# UNITED STATES PATENT AND TRADEMARK OFFICE

10/716,853

<b>Office Action Summary</b>	<b>Application No.</b> 10/716,853	<b>Applicant(s)</b> GANDRAS, ERIC JOHN	
	<b>Examiner</b> Phillip Gray	<b>Art Unit</b> 3767

## **DETAILED ACTION**

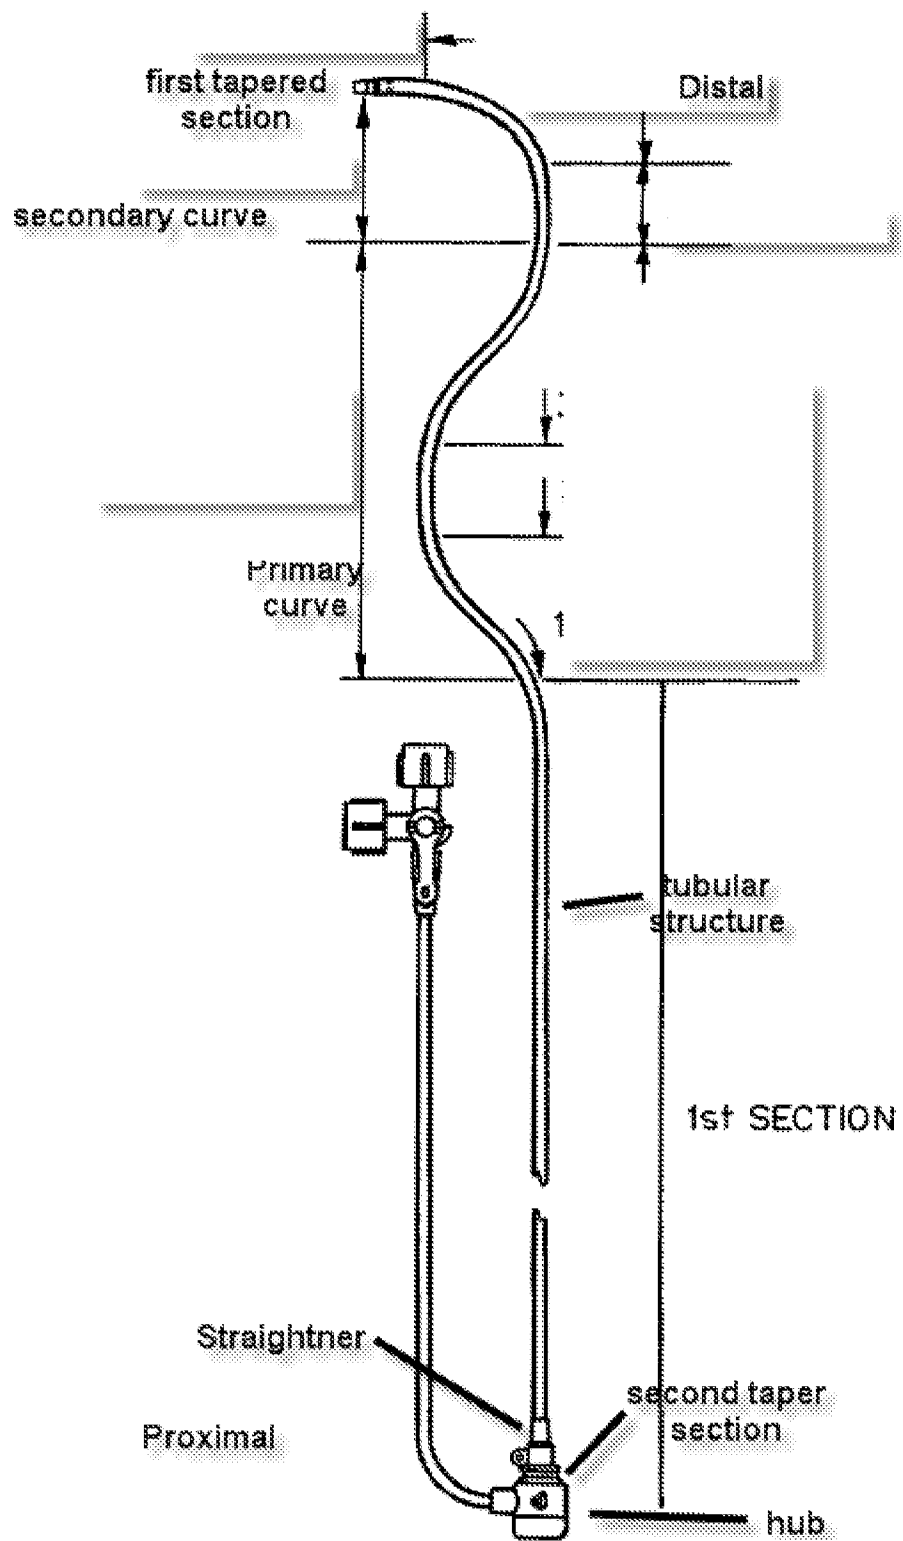
Swartz discloses a guiding introducer. Swartz discloses a catheter (as in figure 2b for example) with a tubular structure, defining a single lumen, a primary curve (see marked figure below), a tapered section distal to the primary curve (see marked figure below), a secondary curve distal to the primary curve, wherein the first tapered section

generally coincides in location with the secondary curve, and a straightener (see figure below).
